**Regional Linear Park Phase II
(Hike & Bike Trail)
Change Order #1**

Project: RLPPII
Contract: C-18-199-02-12
CSJ: 0921-02-409
Limits: Hall Acres to Ridge Road

CONSTRUCTION CONTRACT CHANGE ORDER NUMBER: 1

Sheet # 59 a

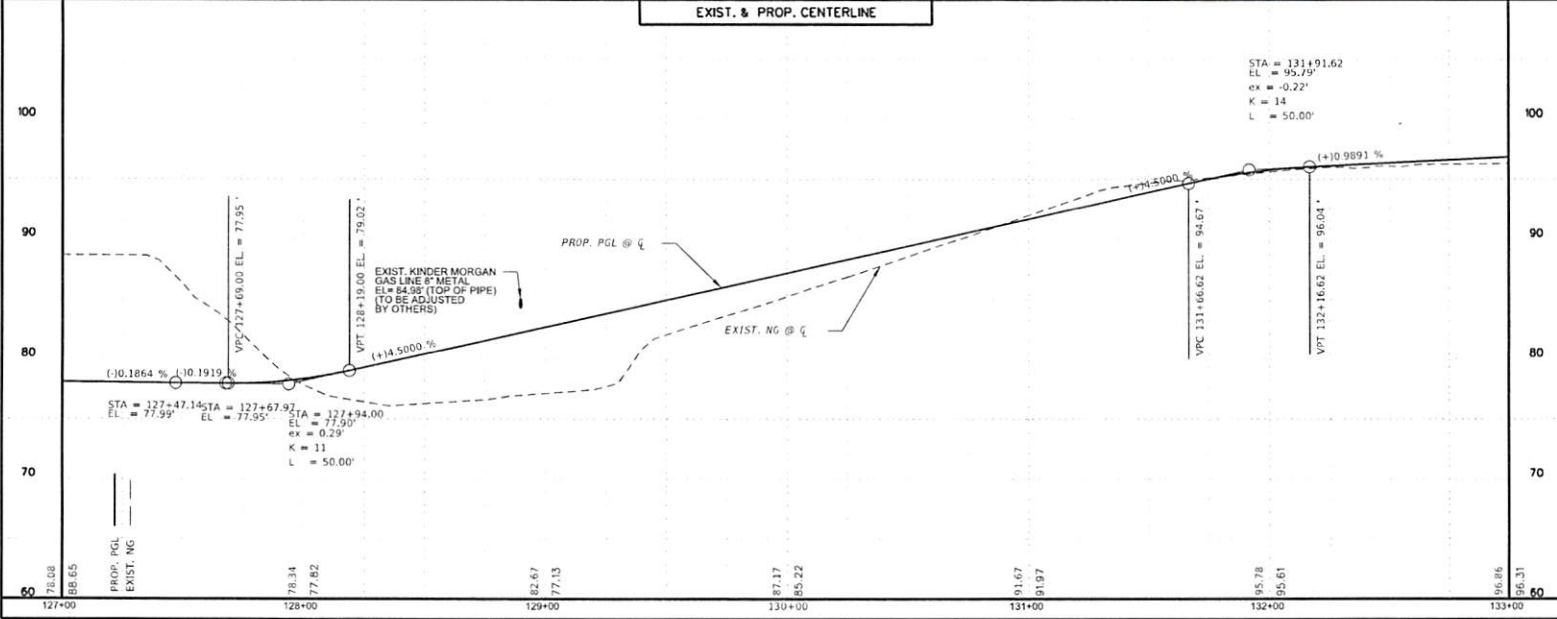
The plans did not identify a crushed 24" RCP located at Sta. 131+00 which was located during the excavation operations on the pedestrian trail which had to be removed and replaced. The plans did not address the extension of an existing 30" RCP at the outfall at Sta. 140+75 which needed to be addressed in order to accommodate the embankment fill for the trail in this area. No time will be added by this Change Order.
